Providence City Plan Commission

AGENDA ITEM 5 ■ 541 HARTFORD AVE

OVERVIEW

Site plan with ground floor

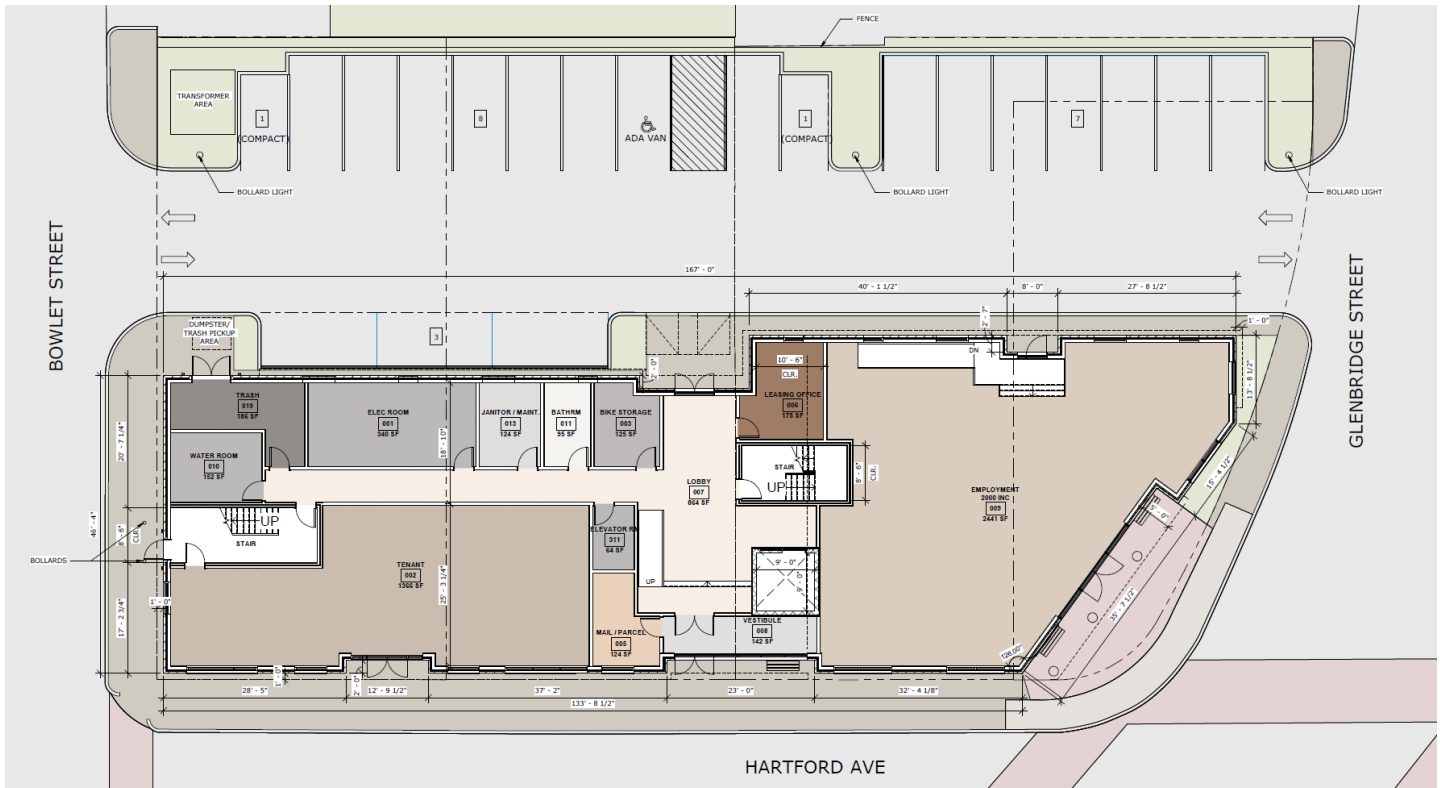
The building will be located at the corner of Hartford and Glenbridge Avenues, with the side lot line on Glenbridge Ave curving outward from the intersection with Hartford Ave. The development is currently composed of four lots and will measure approximately 17,021 SF upon merging. Approximately 31,081 SF of gross floor area is proposed. The proposed height of 47' and four stories is within the 50' four story height limit of the zone.

The existing building which is used as an employment center will be demolished. Hartford Ave will be designated the front yard, providing direct pedestrian access to the commercial and residential areas, with the building set to the front and side lot lines. Encroachment permits will be required for the building footings and for canopies that will project over the sidewalk.

The employment center will be accessible from Glenbridge Ave. The applicant has requested design waivers from the requirement that building entryways be no wider than eight feet, and from the 40% build-to percentage on the corner side lot line. Entrance widths of approximately 13' and 23' are proposed for the building on Hartford Ave and a width of approximately 36' is proposed for the Glenbridge Ave entrance.

Parking will be located in the rear yard with two-way movement provided from Bowlet Street and Glenbridge Ave. A total of 33 spaces are required but 20 will be provided, for which the applicant has requested a dimensional adjustment. The transformer will be located in the rear yard and accessible from Bowlet Street.

The employment center, a retail space, leasing office, mechanical equipment and trash collection area will be located on the ground floor. Thirty units will be located on the three upper stories with nine one-bedroom units and one two-bedroom unit on each floor. Based on provided plans, the building will conform to the design guidelines for multifamily development outlined in Section 1202 K of the ordinance. The design meets this requirement by employing varying, but consistent treatments for the exterior with projections on the façade on all frontages. Brick and glass will mainly be employed on the ground floor with blue hardie lap siding and wood siding used for projections over grey hardie panel on the upper stories. All listed materials are permitted by right in the C-2 zone. Over 50% of transparency will be provided on the ground level with over 10% of transparency on the upper stories.
